CITY OF JERSEY CITY

Department of Housing, Economic Development & Commerce
Division of City Planning
Interdepartmental Memorandum

DATE: 1/25/2022
TO: Planning Board Commissioners
FROM: Cameron Black, AICP, PP, Senior Planner
RE: 21 & 23 Highland Avenue
Case # Z21-005
Case # Z20-105
Case # Z20-106
Block 13303 , Lot 15, 16, and 17
Minor Site Plan/subdivision with "c" and "d" variances

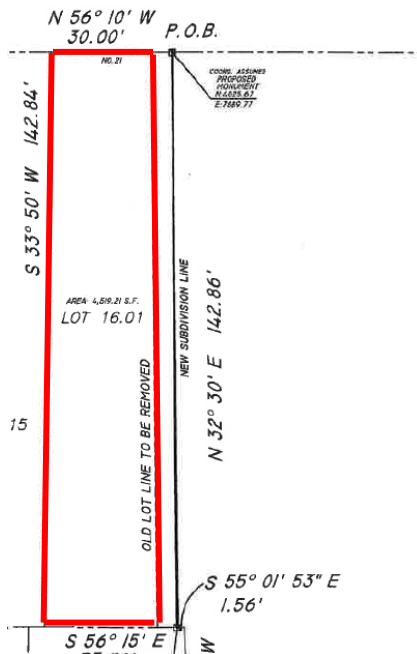
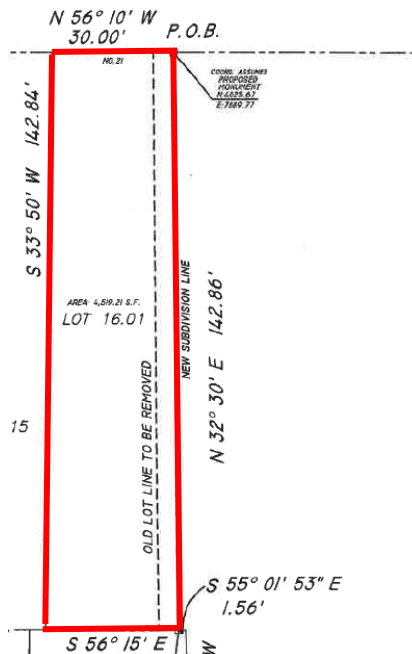
The proposed subdivision plat shows a new configuration as shown below in the right-hand image outlined in red. The lot depth of lot 16.01 will not change (142'), only the width will change (25' to 30') to incorporate the land that has been used as a driveway, which is a 5' increase in width. The subdivision will remedy the issue of a gore between the Church and lot 16 where there is a fence and driveway that encroaches onto Church property. The new boundary will move the existing property line to align with the existing fence and driveway line and to account for the gore between the two properties. The applicant is proposing the subdivision as part of and contingent on approval of the proposed preliminary and final major site plan for the entirety of the project area.

II. STAFF COMMENTS REGARDING SUBDIVISION:

1. Plat bulk requirements table needs to be incorporated and updated with regards to all variances requested.
2. Resolutions of the subdivision and site plan are filed with the deeds for these new lots.
3. All comments made by the Jersey City Engineering Department and Tax Assessor must be incorporated in the final signature plans.

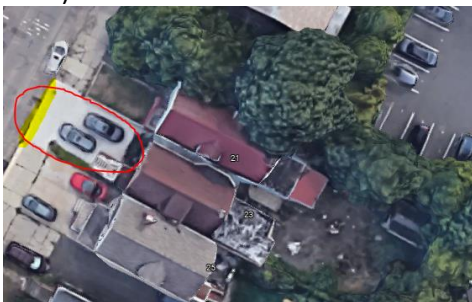
Lot 16.01 and 15 have had single family homes onsite since the 1923 tax assessment and illegal existing nonconforming parking has been modified onsite sometime between the 1930s and early 2000s. The proposal will bring the property back into conformity for circulation and parking (see image below with front yard parking circled in red).
